At last week's meeting concerning the Hancock Village expansion, the question was raised as to whether Chestnut Hill Realty was requesting a waiver for the height of the apartment complex. I have enclosed page 122 from their original submission entitled "Project Eligibility Letter" which specifically states that they are not requesting a waiver since, according to their interpretation, the height is less than 35 feet "Per interpretation of Zoning Bylaws Section 5.01, Table of Dimensional Requirements."

Dimensional Zoning Analysis and Waiver List

I would like in this letter to review the proposal by Chestnut Hill Realty (CHR) regarding the apartment tower, and explain why this violates the spirit and the letter of Brookline zoning.

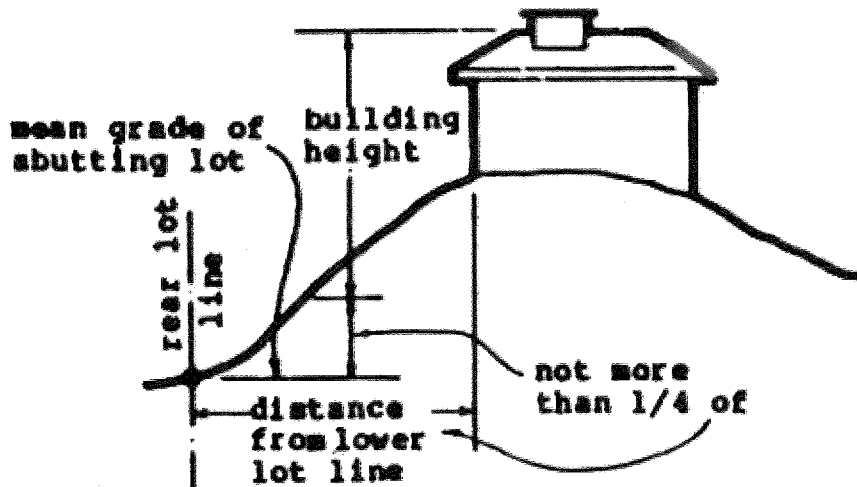
“Where the mean grade of the natural ground contiguous to the building is higher than both the record grade of the street and the mean natural grade of any abutting lot at the lot line, height shall be measured from a level not exceeding the mean grade of the lowest of any lot by more than one-fourth of the distance between the building and said abutting lot line.”

I believe that CHR is deliberately misinterpreting the use of the word "level" in their calculation of the height. As shown in the diagram, this word does not mean that they are allowed to add the distance; it means that the height is to be taken *at this point*. Thus, they have misconstrued a standard that is intended to protect the surrounding properties in such a way as to allow them virtually unlimited height in their construction.

I therefore request that you find this calculation to be in error. Using the plot diagram that they have given, the building cannot be more than 30 feet above the level of Asheville Road.

Attachment 1. CHR site section for Building 13 showing 72 foot elevation above Asheville Rd

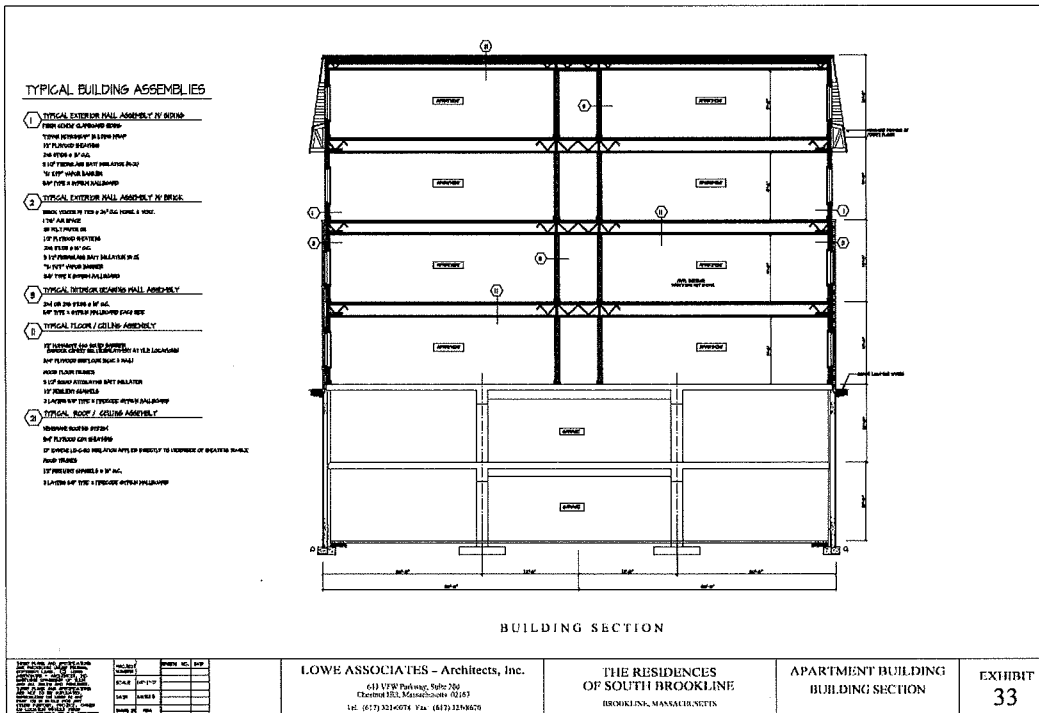
As I have previously noted in my oral presentation, the building labeled "Apartment 13" is described as a four story building. However, as is explicitly shown in their architectural diagrams (Attachment 1), this is a misnomer. The building is actually 72 feet above street level of Asheville Road. This is in an M0.5 area that is approved for buildings 35 feet in height. Since they now intend to have an extra level, this will be a minimum of 83 feet above street level and may be taller with the decorative attics.

HEIGHT CALCULATION PLAN SOUTH-EAST

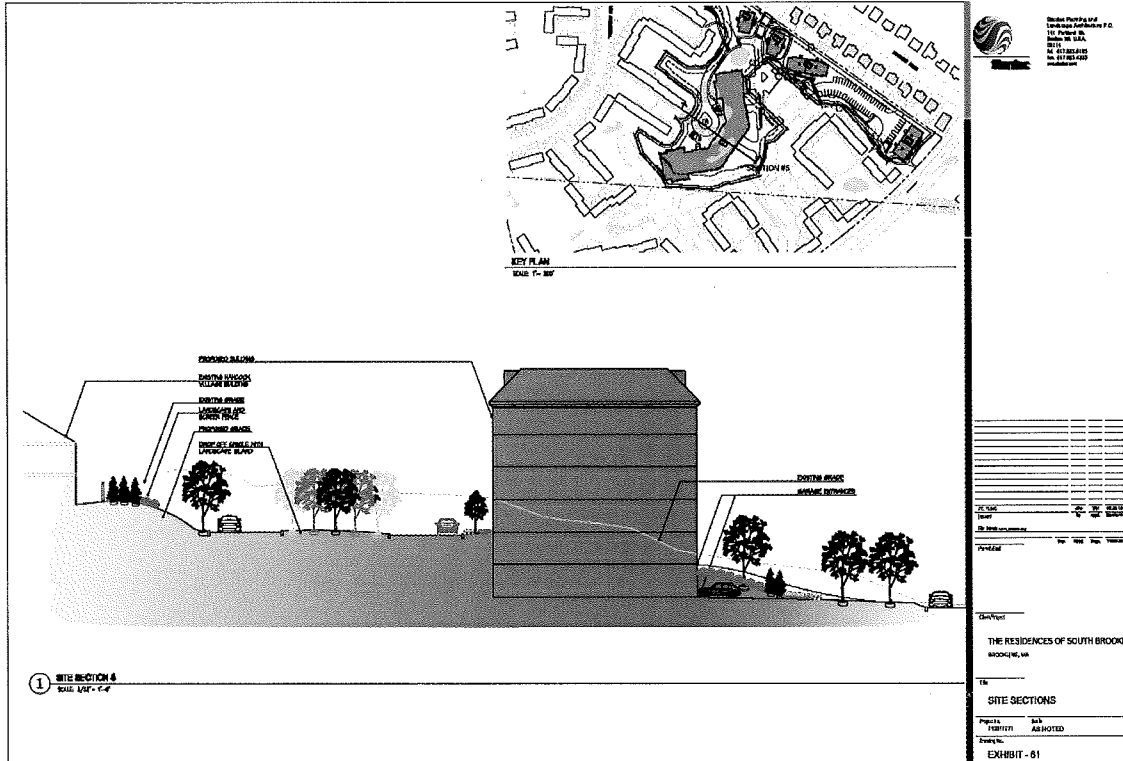
In their calculations, they use the absolute height above sea level from their survey as follows (Stantec L104):

Thus, they state that they can build a 143 foot tower (299 ft-156 ft) in an area zoned for a 35 foot maximum. They have not requested a waiver for this.

I believe that this calculation is seriously in error. Please note that the formula that they are using does not appear in any way in the Brookline Zoning handbook. The exact wording of the paragraph in question is as follows:
